THE CITY OF WALTHAM  
MASSACHUSETTS

**PHASE II RENOVATIONS TO THE FORMER BANKS SCHOOL ELDERLY HOUSING  
CONDOMINIUMS AND  
PHASE III RENOVATIONS TO THE FORMER BANKS SCHOOL ELDERLY HOUSING  
CONDOMINIUMS**

**ADDENDUM NO. 1**

September 7, 2012

250 DORCHESTER AVE BOSTON, MA 02127 P: (617) 268-8977 F: (617) 464-2971 CBI@CBICONCONSULTINGINC.COM	<b>BANK SCHOOL RENOVATIONS</b>		SHEET No. <b>SK-01</b>
	DATE <b>06/08/2012</b>	CHECKED	DESCRIPTION	
	REVISION REVISION	SAW	ADDENDUM #1 PARTIAL FIRST FLOOR PLAN	
				PROJ.# 10025-A

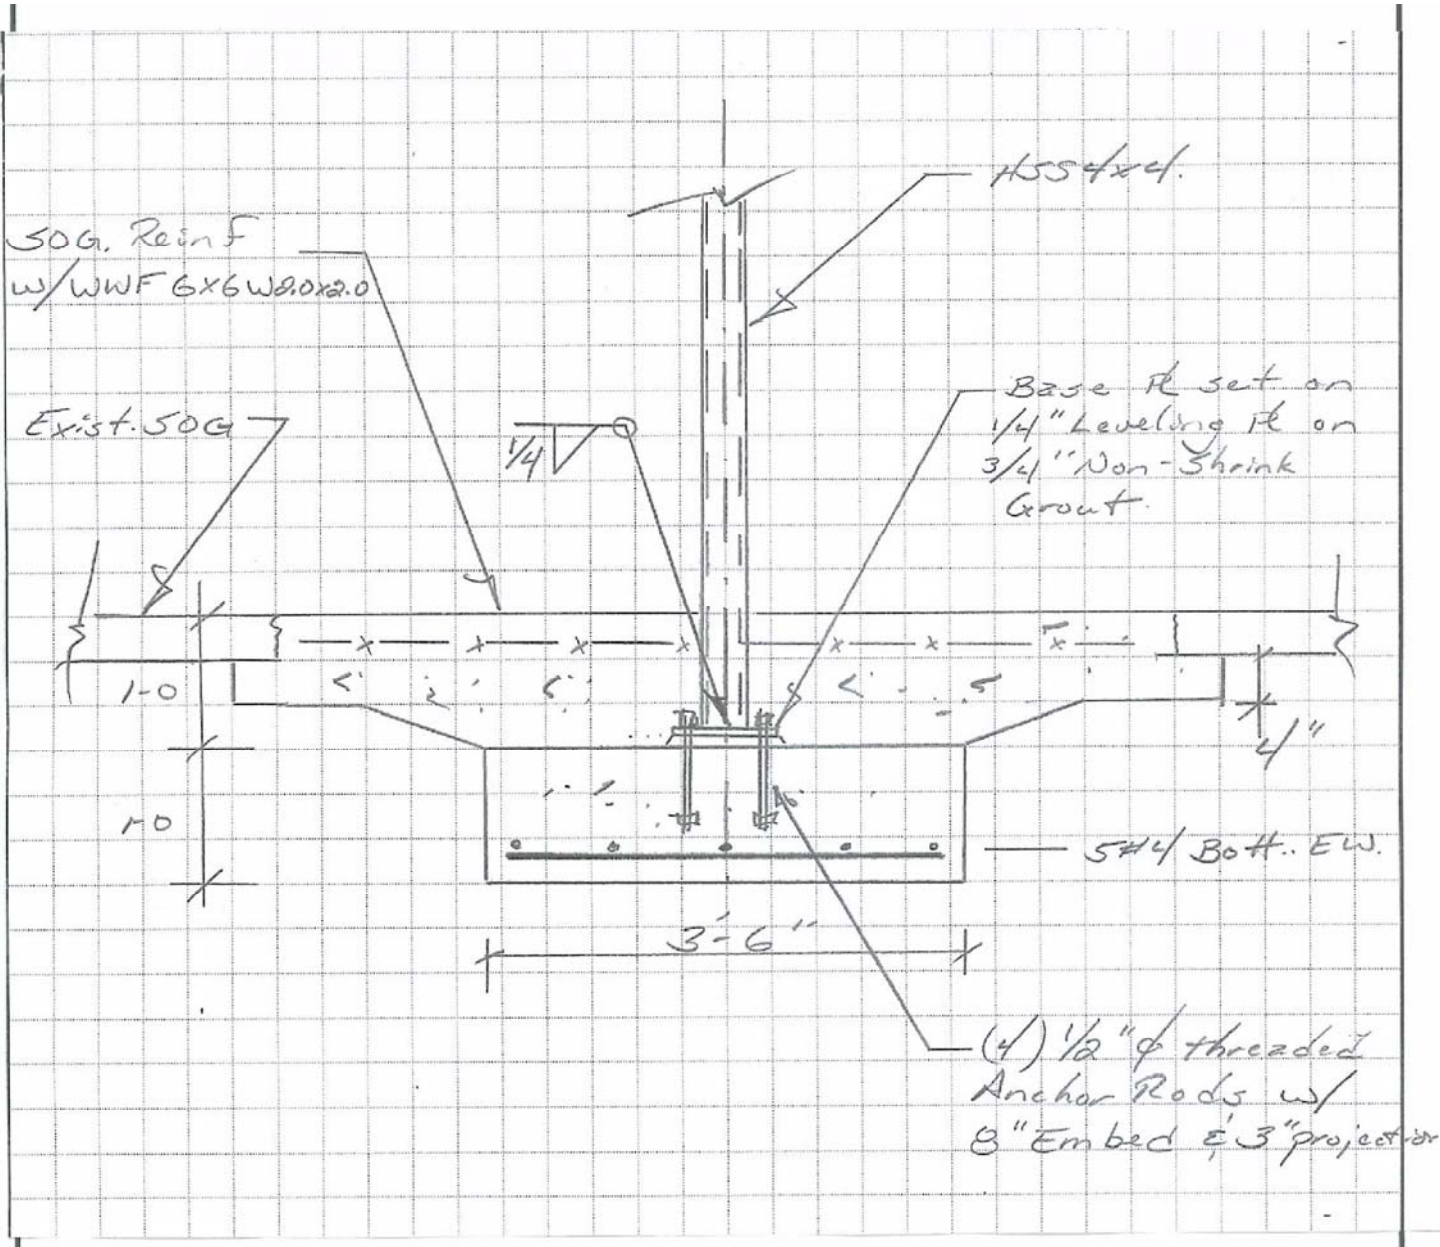
10. PHASE II; STRUCTURAL DRAWINGS: **ADD** SKS-1 through SKS-5 (attached). Work includes but is not limited to the partial removal of existing first floor slab-on-grade for the placement of a new footing, removal of existing tile and grout floors at second and third floor toilet rooms in the southwest corner of the building (Room #203C and unoccupied Unit 303 bedroom), fabrication and erection of one (1) 2-story column and two (2) steel beams and associated connections. Steel beams shall be pocketed at one end into existing masonry wall. Work includes new wood blocking and built-up plywood subfloor to align with existing adjacent wood floor (V.I.F.). No field-welding shall be permitted. Means of disposal shall be accomplished without transporting materials through occupied spaces of the building and Contractor shall ensure protection of existing building and occupants during the work.

SHEET No.  
**SK-03**  
PROJ.# 10025-A

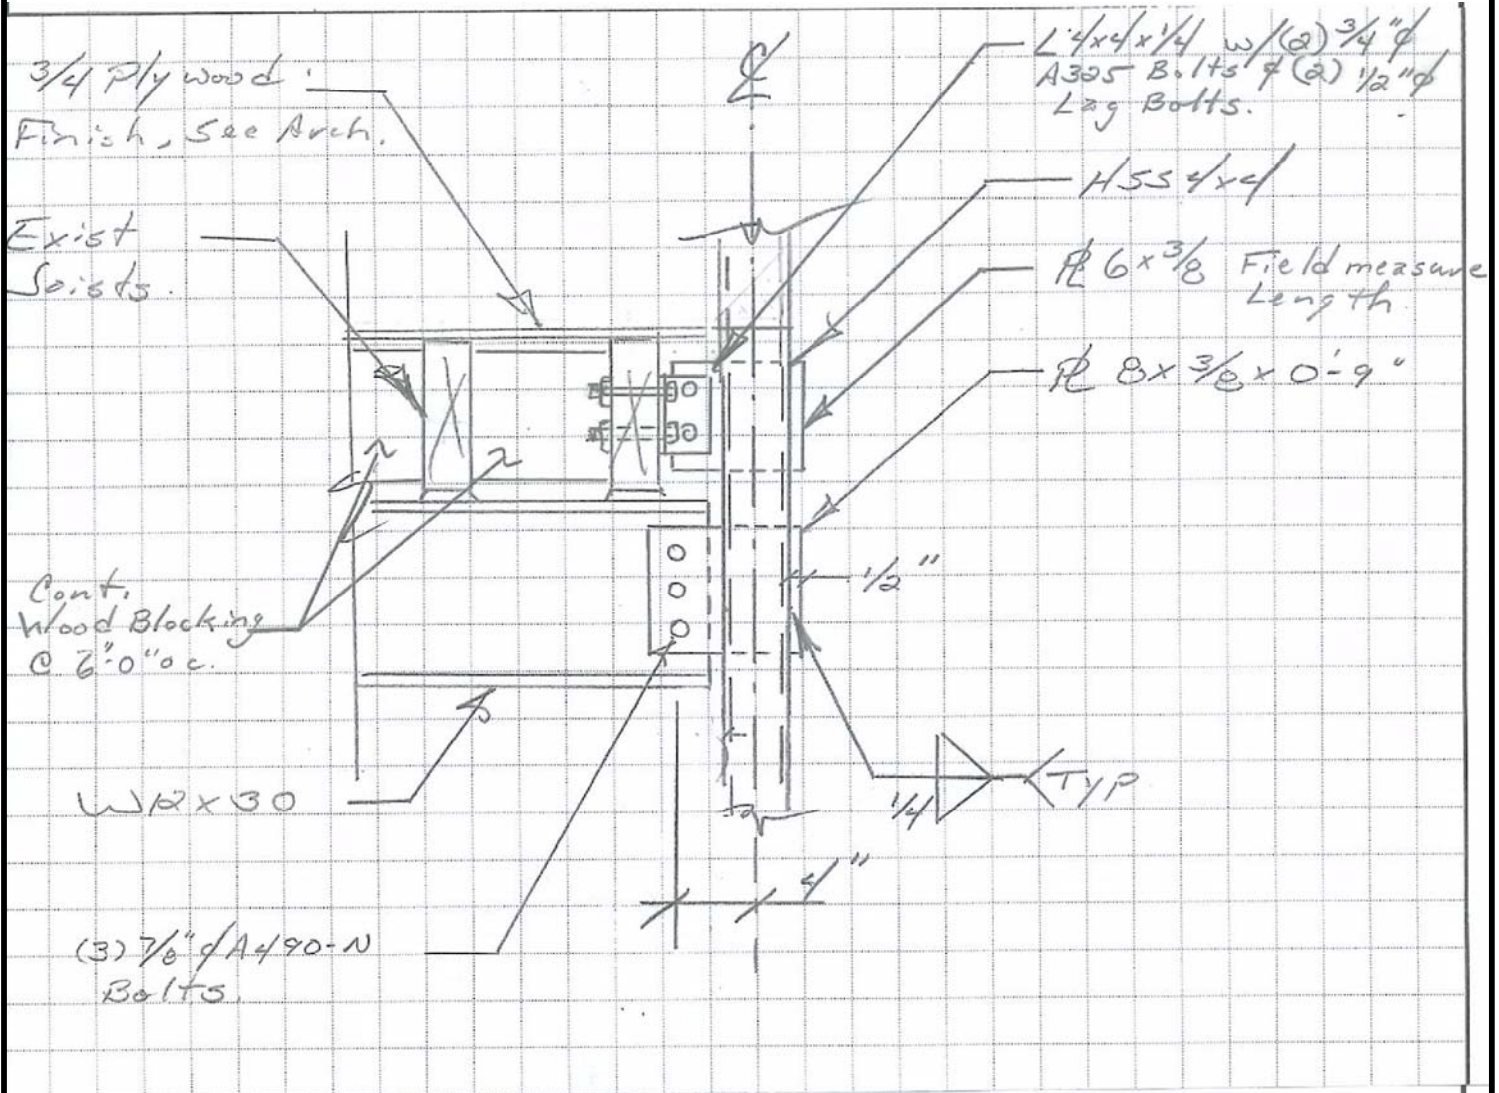
Note: Top of existing joists are not square. Trim & level top of joists to accept plywood sub floor. Coordinate Finish elevation with architectural drawings, and field conditions.

SK-04

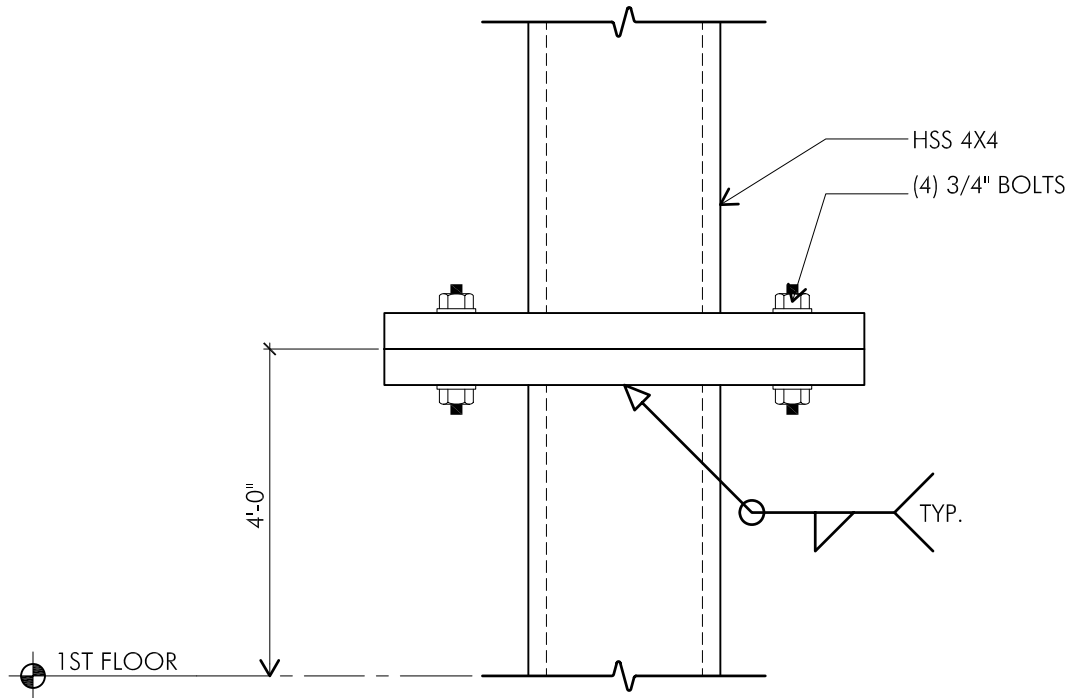
Note: Terminate column with a 1/4" thk cap plate at the top of third floor joists.
